UNITED STATES PATENT AND TRADEMARK OFFICE

10/500,191

Office Action Summary	Application No. 10/500,191	Applicant(s) SANO, MASAHIRO	
	Examiner Geoffrey L. Knable	Art Unit 1791

(PRIOR ART)
Fig. 2

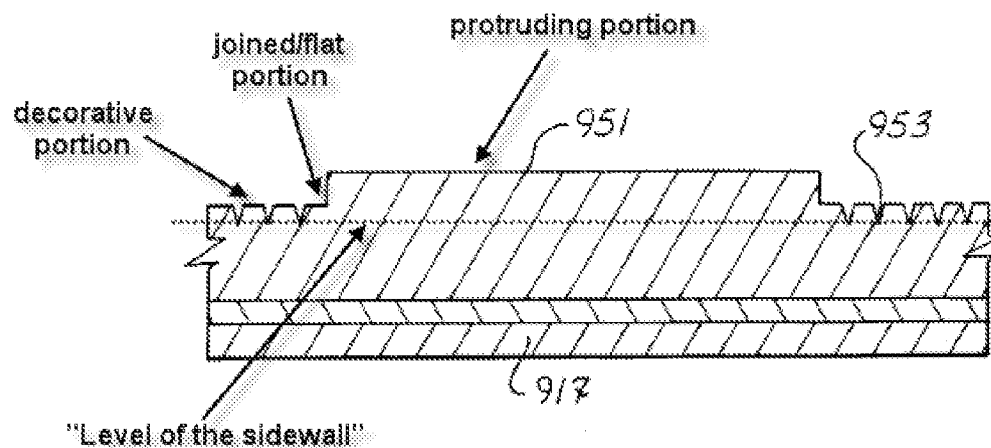
Kemp et al. discloses a tire having a sidewall pattern that includes a decorative serrated portion (953), protruding portions (951) and a joined portion that joins the protruding portion to the decorative portion, this joined portion being higher than the bottoms of the serrations - note the following marked up copy of fig. 2:

A tire as required by claim 1 is therefore anticipated by this disclosure. As to claims 2 and 8, since the "high decorative portion" is not distinguished from other parts of the decorative portion (e.g. it could be termed high if it is further radially outward on the sidewall), this reference also includes a serrated high decorative portion between protruding portions (e.g. between letters) and second joined portion.

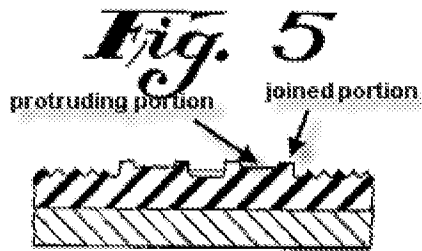
As to claim 3, because of the angled orientation of the serrations (953 - fig. 1) and their flat tops, they define flat/joined portions that extend between protruding portions (i.e. between letters).

As to claims 9/11/13, Kemp et al. shows groups of letters.

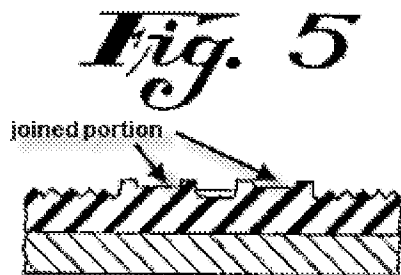
Vizina discloses a tire including serrated decorative portion superimposed with protruding marks (esp. figs. 2 and 5). Further, higher joined portions that join the protruding portions to the decorative portion and thus read on the claim 1 requirements are provided as indicated in the below annotated fig. 5.

Claim 1 is therefore anticipated by this disclosure. As to claims 2 and 8, again, since the "high decorative portion" is not distinguished from other parts of the decorative portion (e.g. it could be termed high if it is further radially outward on the sidewall), this reference also include a serrated high decorative portion between protruding portions (e.g. between the letters "L") and second joined portion.
